City of Tacoma

Questions and Answers

Odor Control Media Services – 2026 RFB Specification No. ES25-0310F

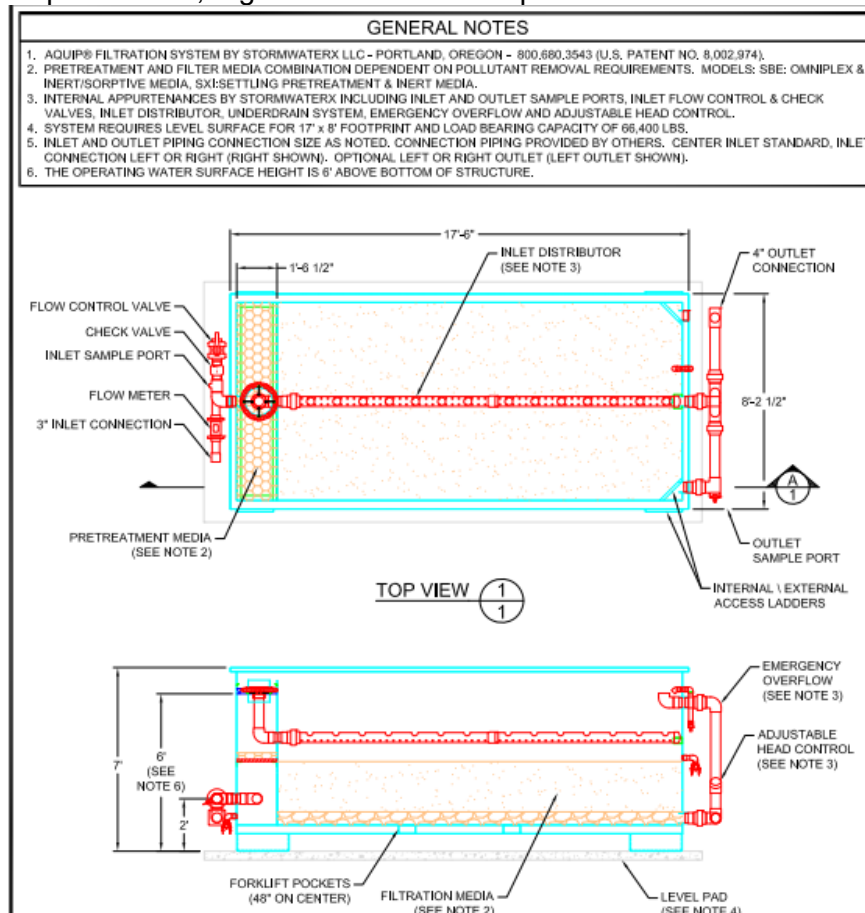
Please provide the manufacturer's specifications for the media required for replacement in the Aquip Storm Filtration System. Layered inert and adsorptive biofiltration media for particulates, organics and dissolved pollutants removal does not give us enough information, nor does coarse sand and fine sand.

Omniplex media and integrated oil skimmer, and down-flow filtration chamber with layered inert and adsorptive biofiltration media for particulates, organics and dissolved pollutants removal

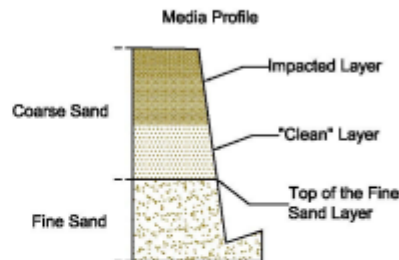
Please provide the specifications and types of media required along with the quantities in cubic feet as was provided for the items 1-4.

the number of inches of "clean" media above the top of the fine sand layer.

8. Conduct a Routine Surface Maintenance on Aquip removing the impacted media from the entire Aquip media bed.

9. Install additional coarse sand "Topper" if the coarse sand depth is less than recommended (see table below).

Specifications	Coarse Sand Depth
Initial depth at time of installation	6"
Minimum recommended "clean" media depth	2"
Minimum recommended total media depth after adding "topper"	4"
